TRANE®

General Service Bulletin

Thrust Bearing Design Change

ORDER NO: CVHE-SB-56A

Figure 1. Center Feed Thrust Bearing Installed

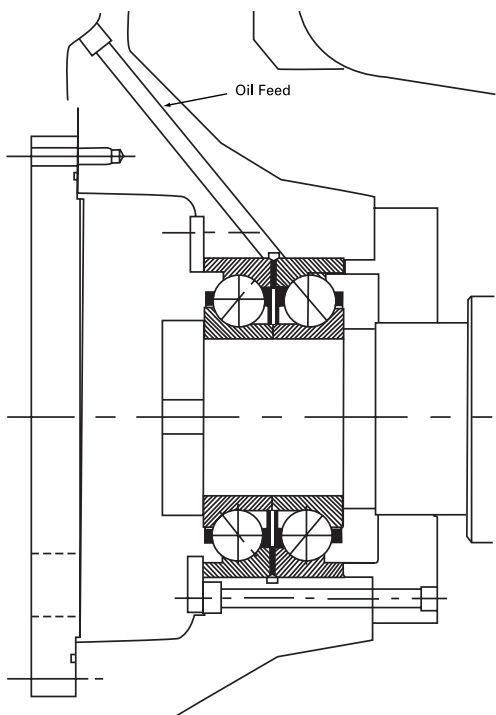
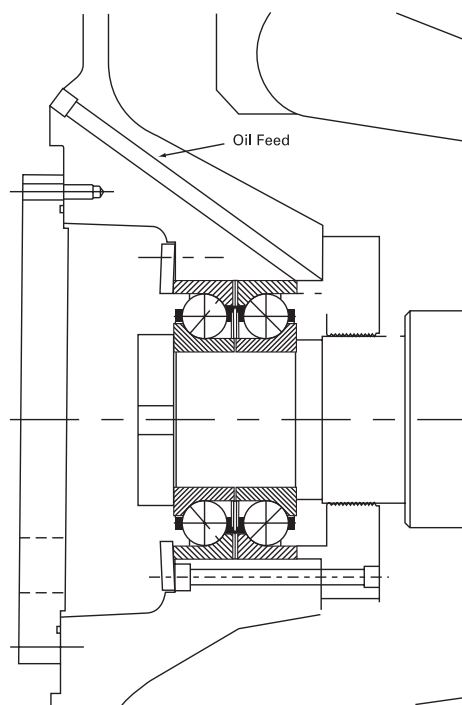
This new design utilizes a center oil feed (see Figure 1) instead of the axial oil feed used previously (see Figure 2). These new bearings (BRG1209 and BRG1210) have shallow grooves machined in the face of the outer races on the back side of each bearing (see Figure 3, Detail A). When mounted on the compressor shaft in a back to back arrangement, these grooves allow oil to be fed to the center of the duplex bearing set. No other change to the bearing is incorporated. These center feed thrust bearings can be used on any CVHE, CVHF, CVHG, CDHF, CDHG compressor with a "K4" marked shaft, whether or not it is equipped with the center feed bearing bracket. In other words, these bearings are backward compatible with any K4 shaft CVHE, CVHF, CVHG, CDHF, CDHG that formerly called for a BRG0609 or BRG0610.

If the new center feed bearing bracket is installed (starting with the design sequence - **See Units Affected Section**) on the machine, the new center feed thrust bearings (BRG1209 and BRG1210) **must be used** or catastrophic thrust bearing failure will occur due to lack of lubrication. For non-K4 shaft compressors, it is imperative to use the BRG0913 or BRG0914 to allow proper interference fit, as outlined in service bulletin CVHE-SB-33B.
